Access Compliance Report Public Rights-of-Way (Curb Ramps)

Main Street: **PIEDMONT_AVE** Cross Street: **WEMBLEY_RD** Location: **N**

ADA ID: **RPAT211206105918** Ramp Type: **Type 1 - Perpendicular Diagonal Initial Pass/Fail: Fail** Overall Compliance: **No** Severity Score: **15**

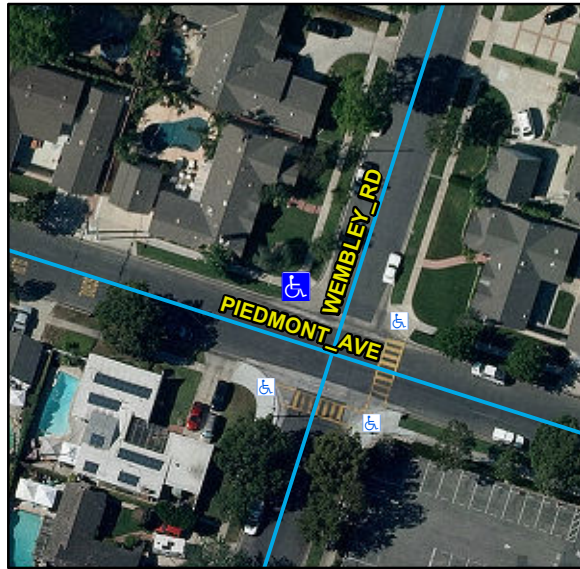
R304.2.2, R204.3, STD 1115

Remove & Replace Curb Ramp With Two New Directional Ramps or Equivalent.
